Staff Report:

Preliminary Plan 120080050: Holladay at Edgemoor

Site Plan 820080030: Holladay at Edgemoor

Creation of one lot for the construction of a 48-unit multi-family residential DESCRIPTION:

Loading Plan

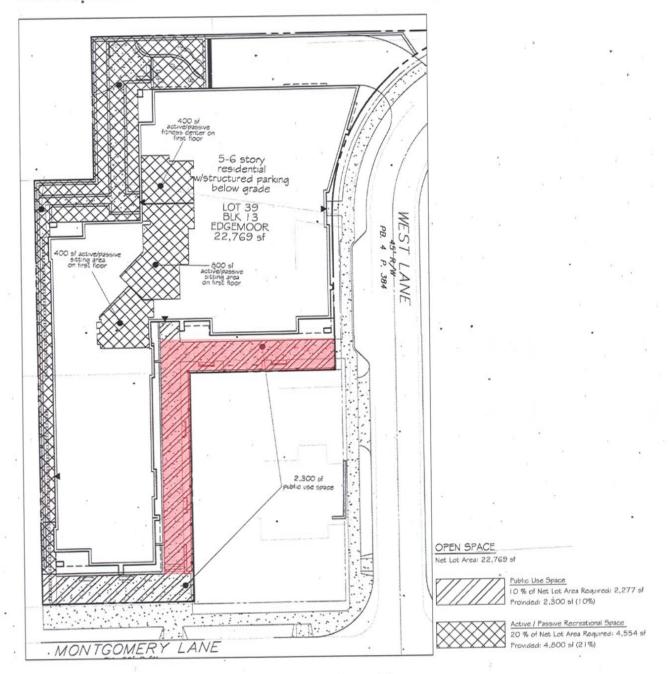
Given the relatively small lot size (22,769 sf. or 0.52 acres) and density (48 units) for this development, the Applicant proposed not to provide a loading space within the building. Their concern was that the loss of dwelling units necessary to accommodate a loading space was not conducive to the economic feasibility of the project. At DRC, DPWT commented that a loading space would indeed need to be provided within the building. Senior and project staff from M-NCPPC, DPWT, and DPS met several times to reconcile each party's concerns, the ultimate resolution of which is a Loading Plan, prepared by the Applicant and approved by all parties. The Applicant has agreed to require residents of the proposed building to conform to the Loading Plan when moving into or out of the building.
